## Contract Routing Form

Project: State St Reconstruction Assessment District-2014

Contract No.: 7206  
Enactment No.: RES-14-00333  
Dollar Amount: 4,733,488.80

1 PL1 PLANTING PLAN - BASCOM HILL/ PARK STREET  
1"=20' @ 11X17

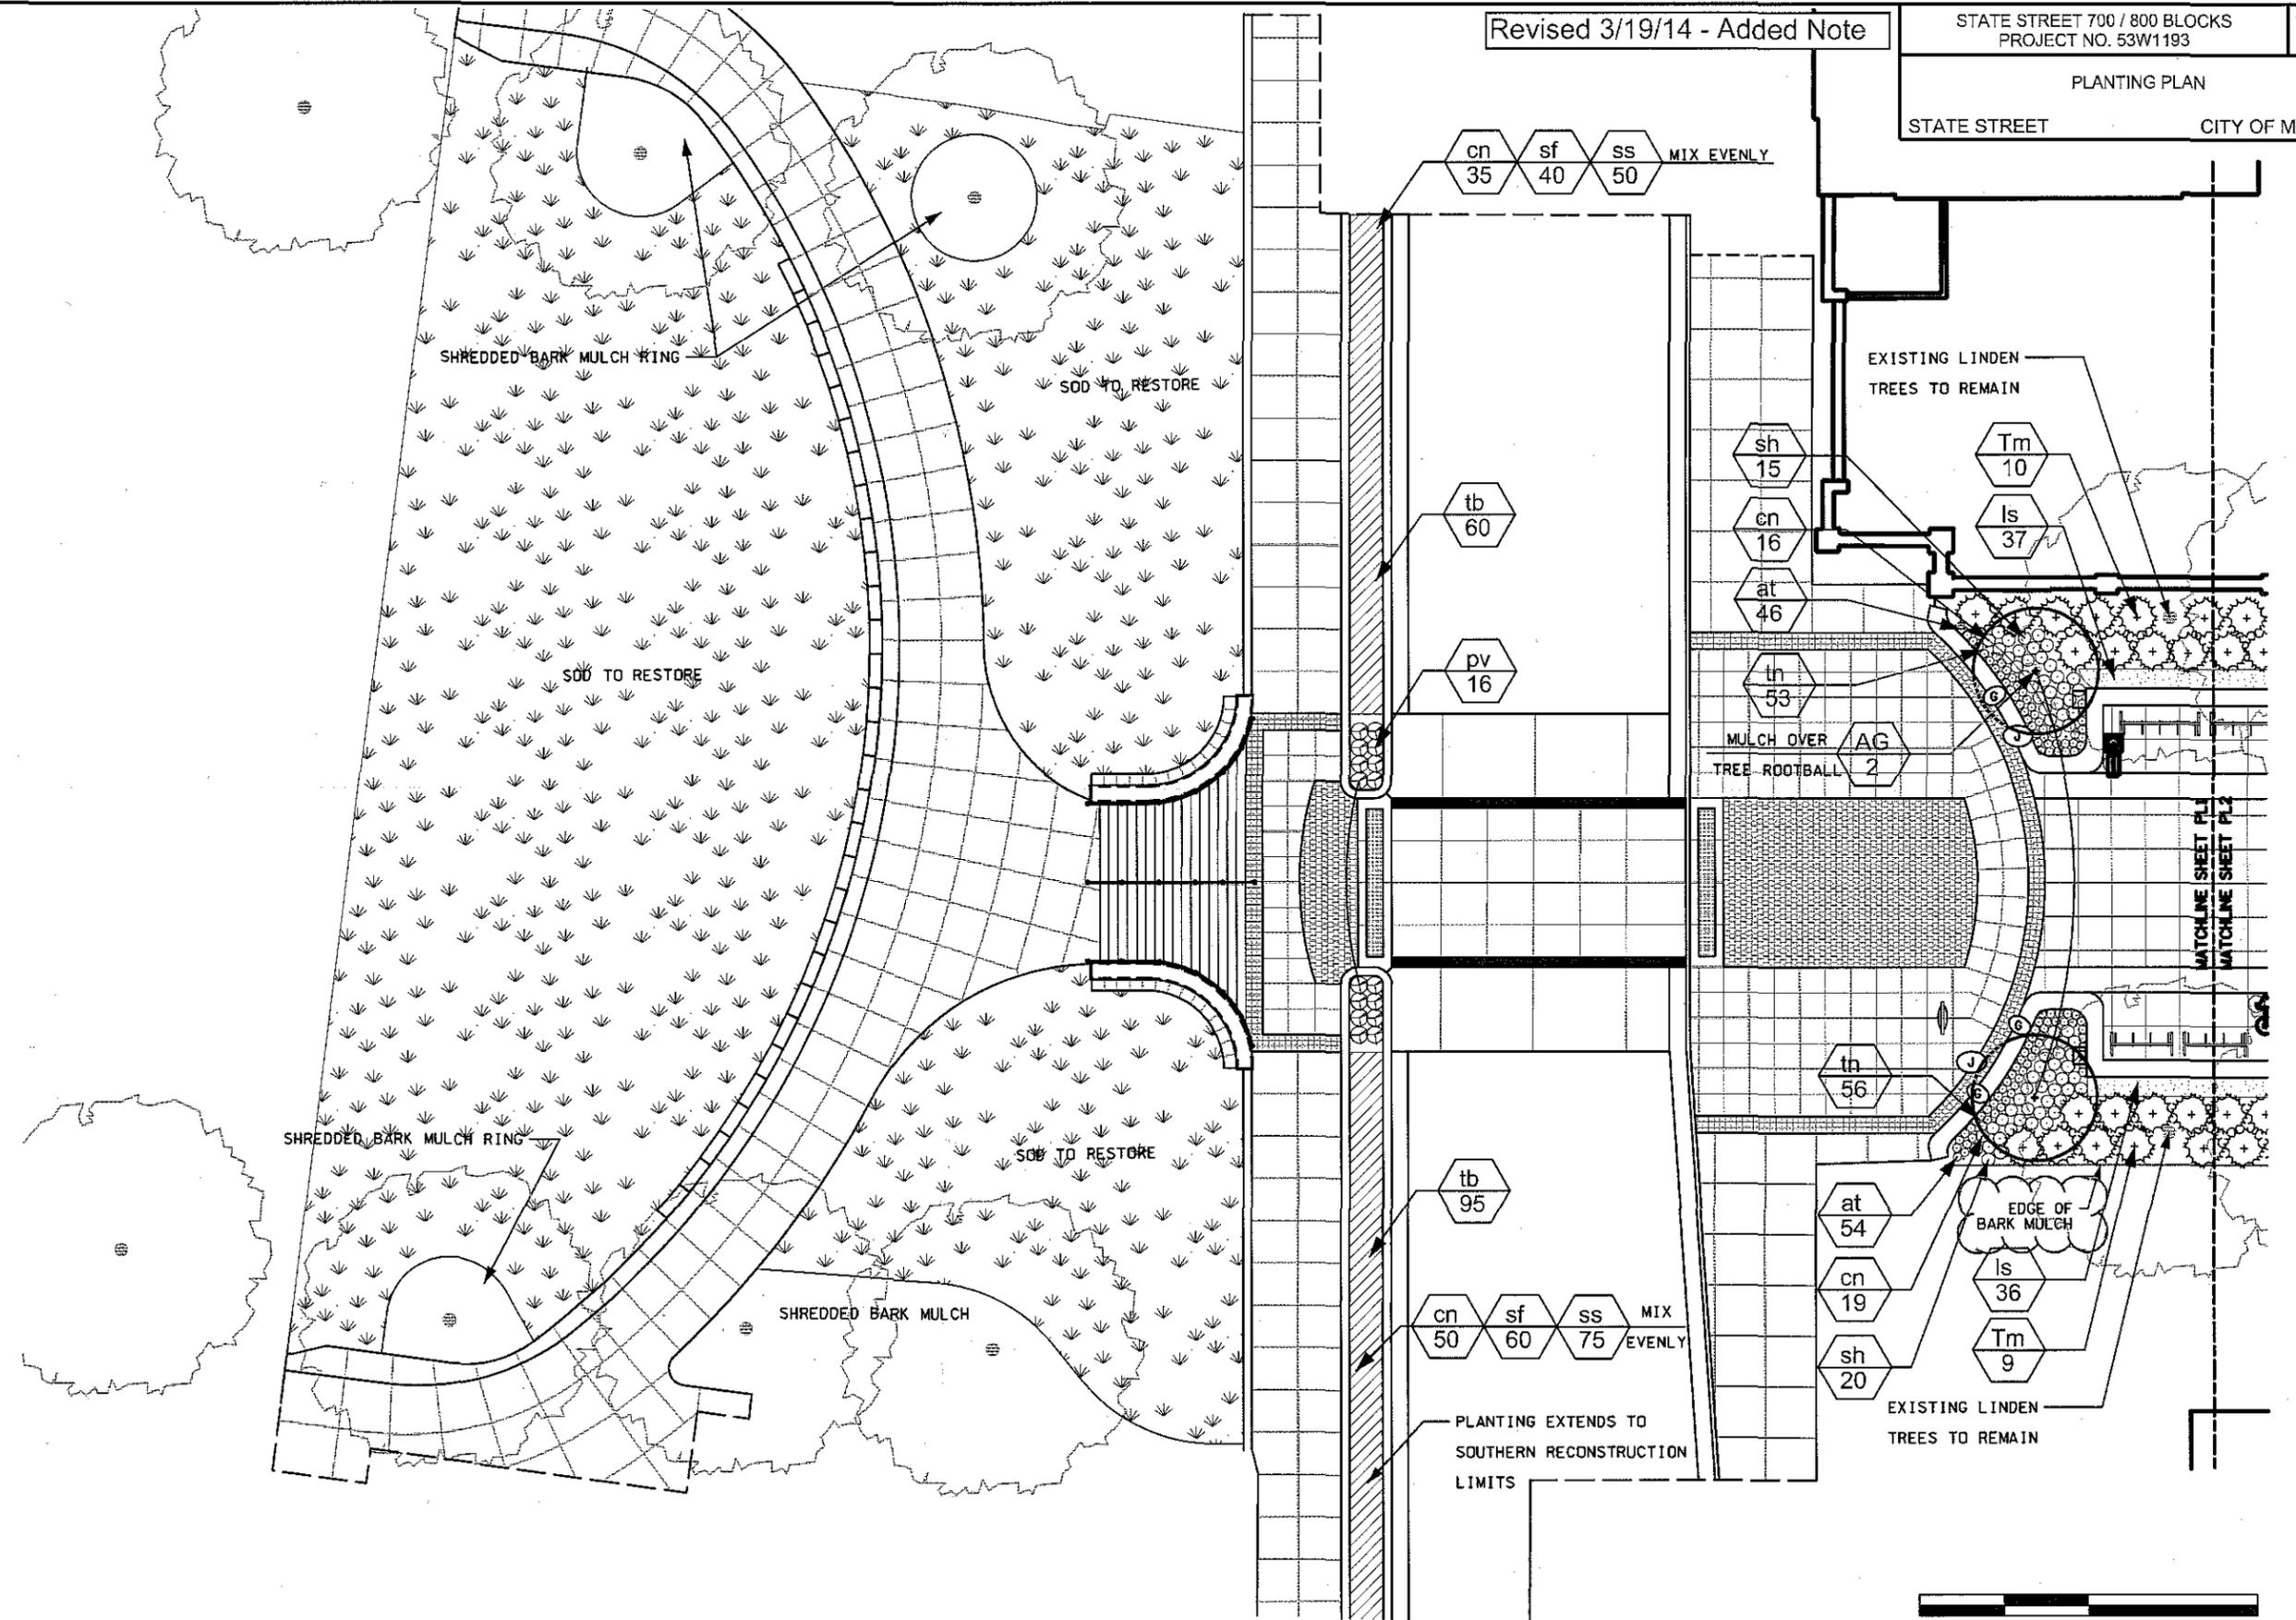
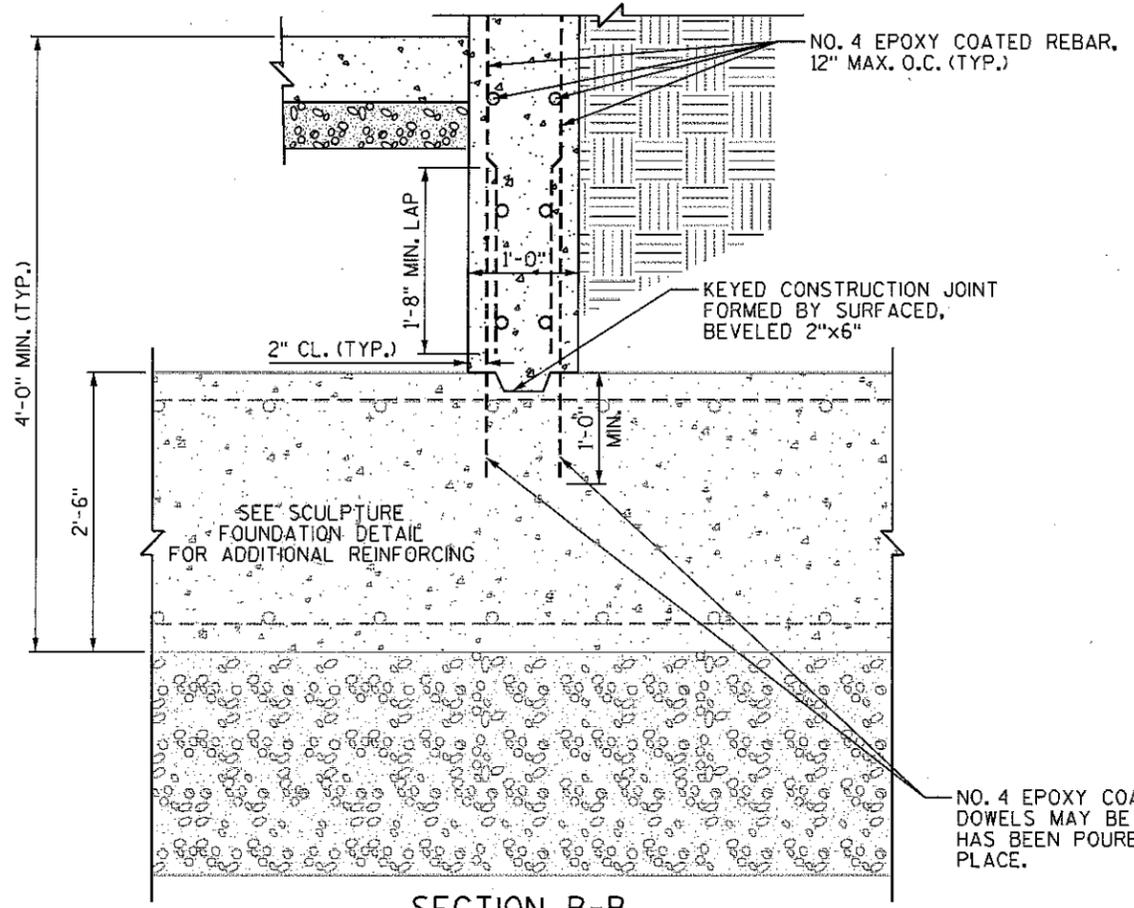
Replace Sheet PL1 (Revised 3/19/14) – Added limits for Bark Mulch item.

Revised 3/19/14 - Added Note

2 PLANTER SEAT WALL WITH PRECAST CAP  
S-26 1"=1'-0"

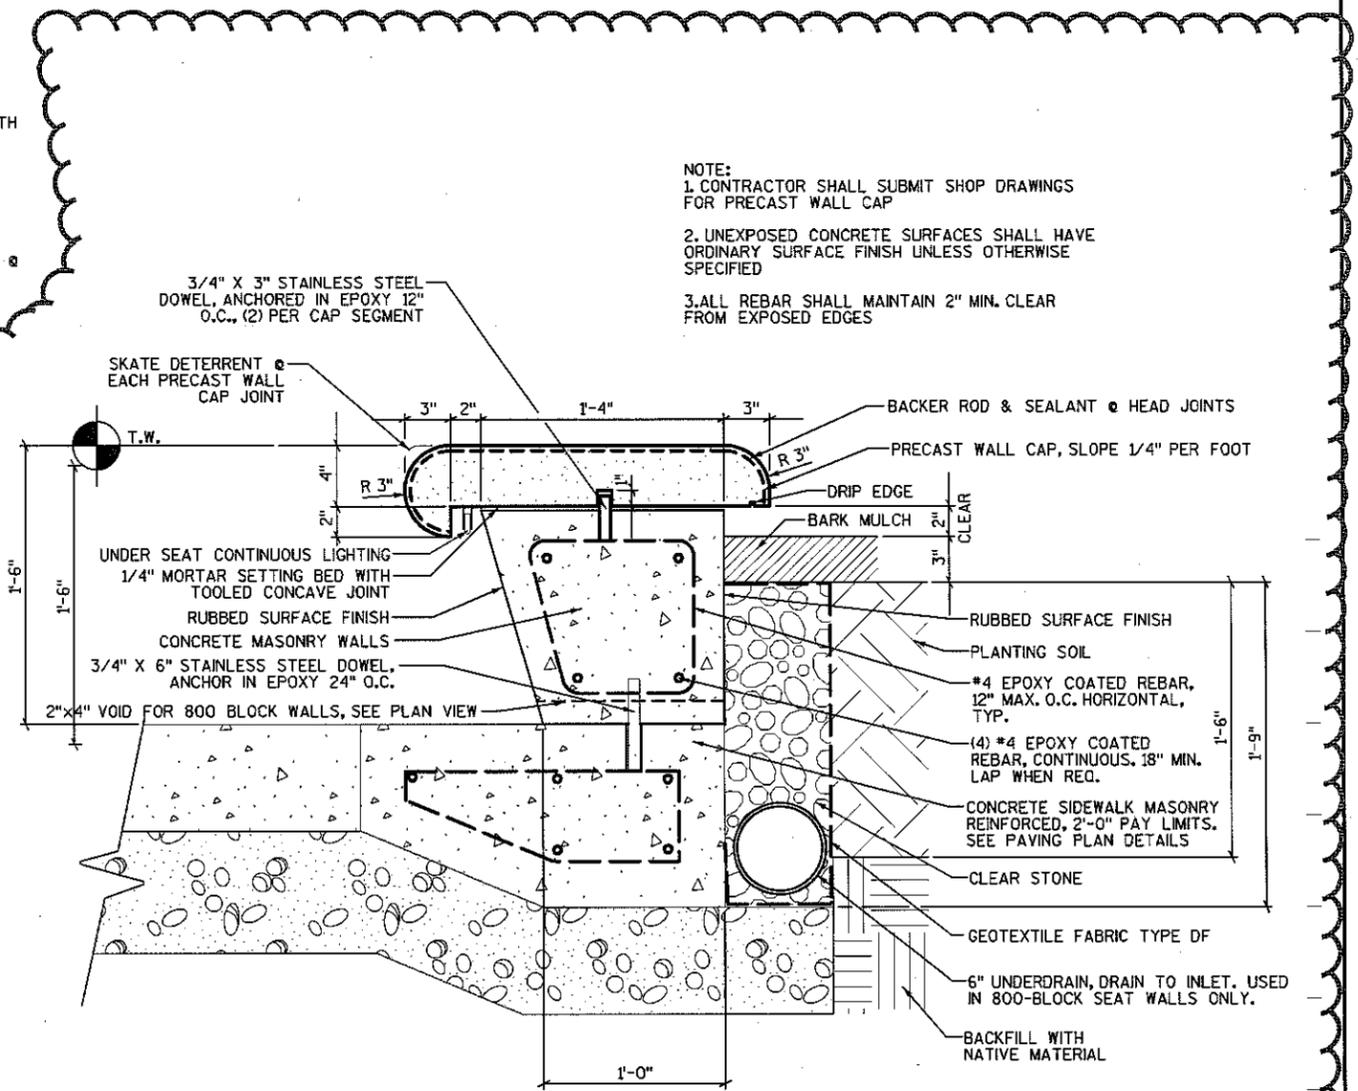
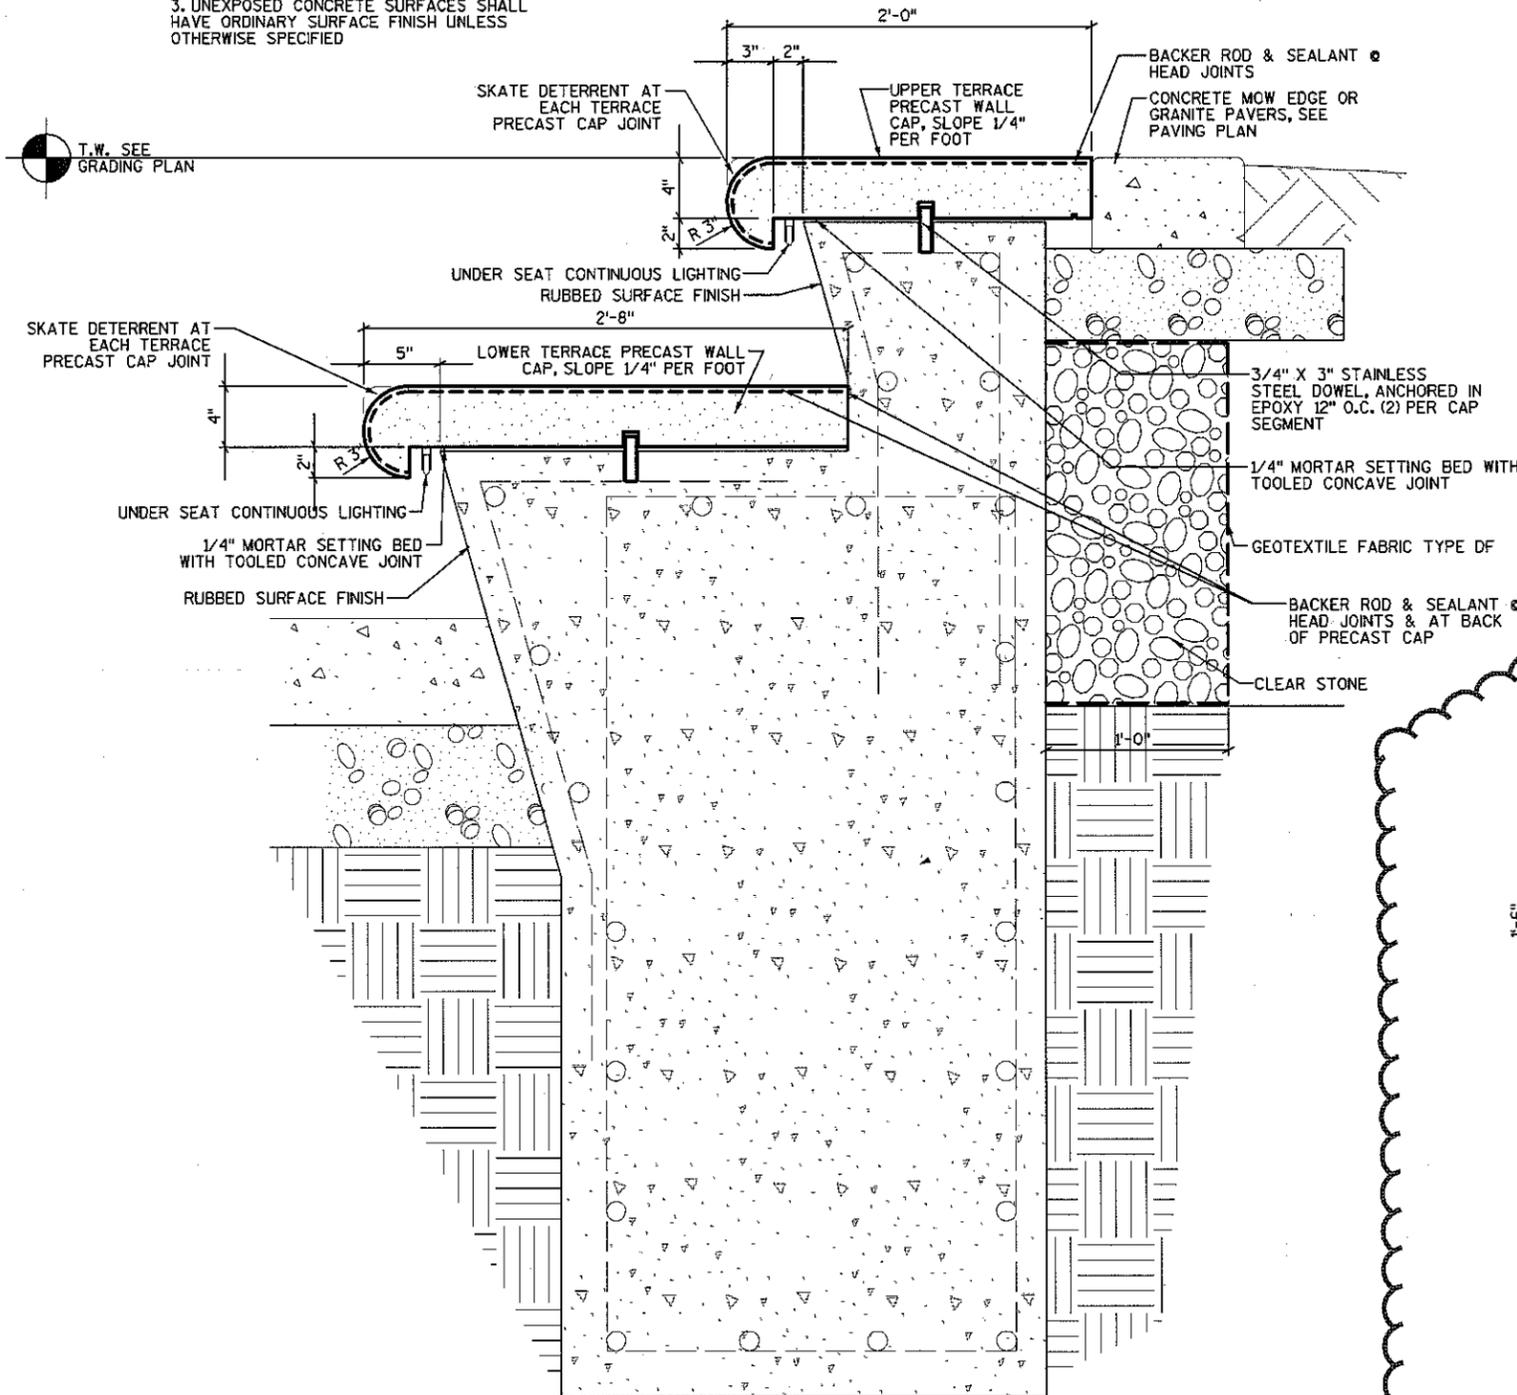
Replace Sheet S26 (Revised 3/21/14) – Added detail for Seat Wall with Precast Cap in planter condition.

REVISED 3/21/14: Added detail for Planter Seat Walls for planter areas in the 700 Block.

1 WOOD DECKING @ LEAF BASE PLAN ENLARGEMENT  
S-25 1/2"=1'-0"

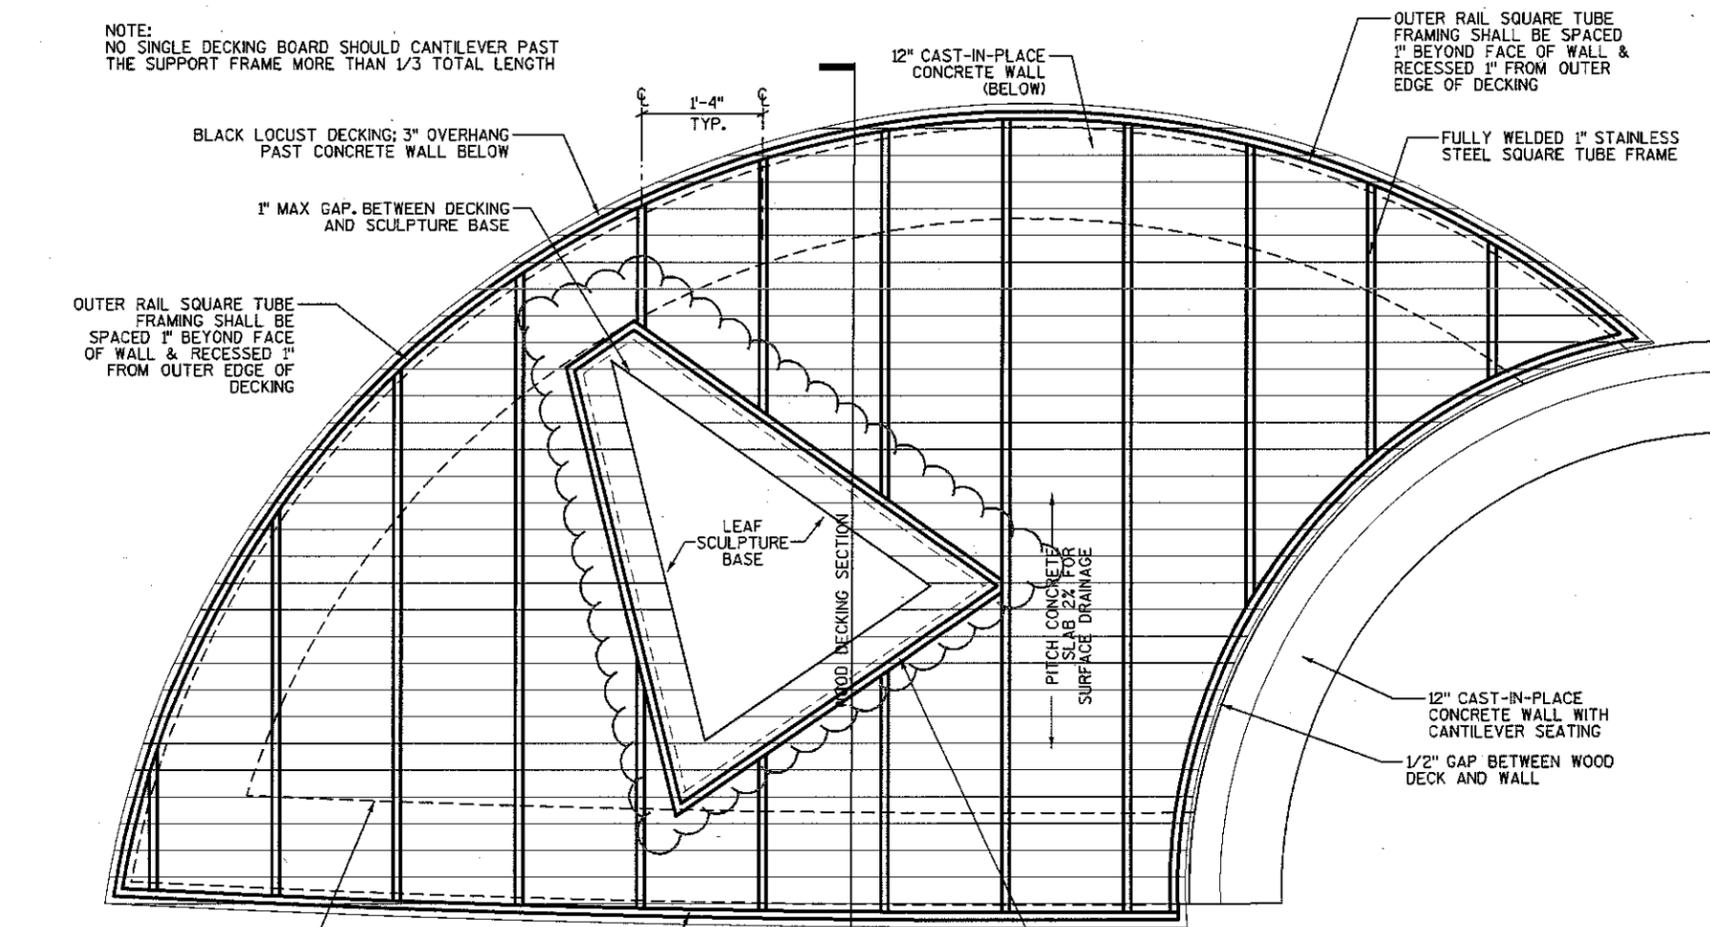
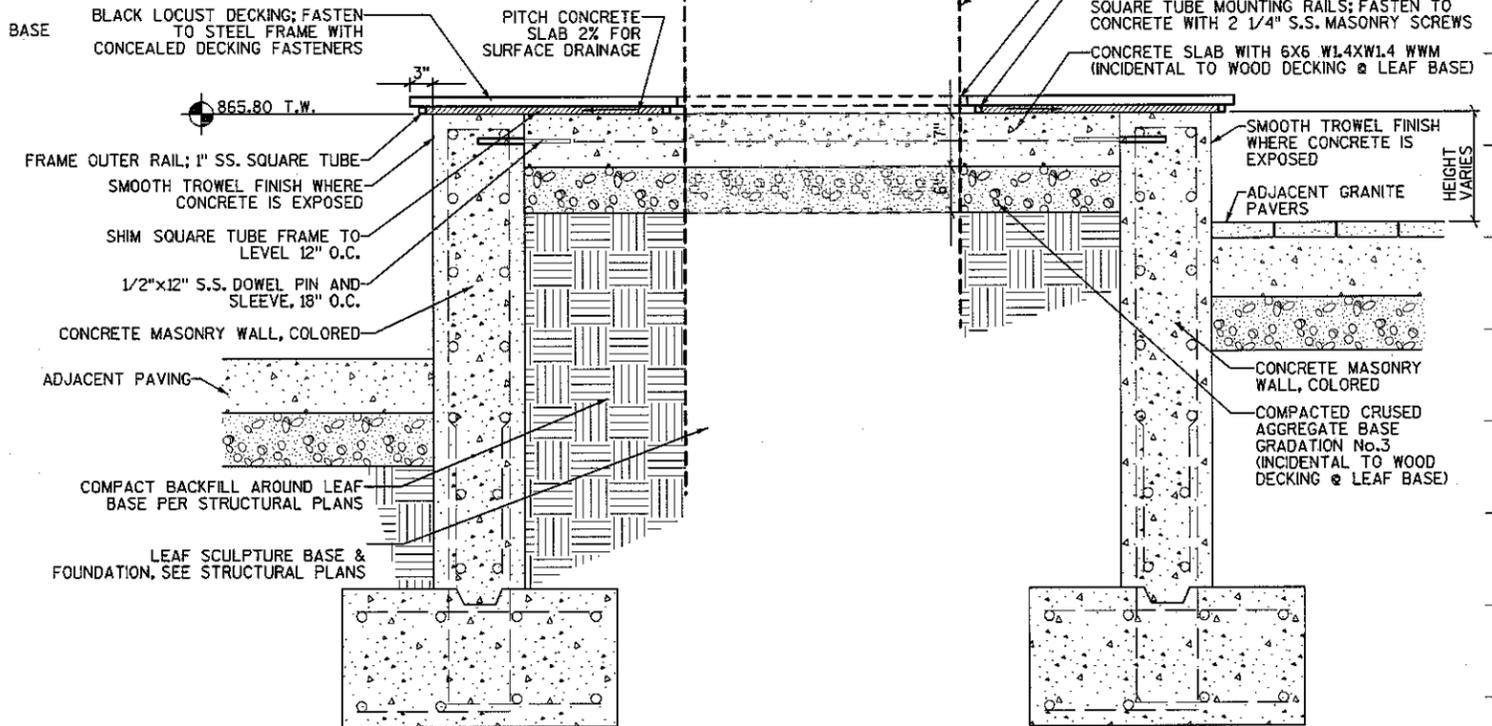
Replace Sheet S25 (Revised 3/18/14) – Updated Wood Decking @ LEAF Base detail – matched shape of

Revised 3/18/14 - Updated Leaf Sculpture Base Shape
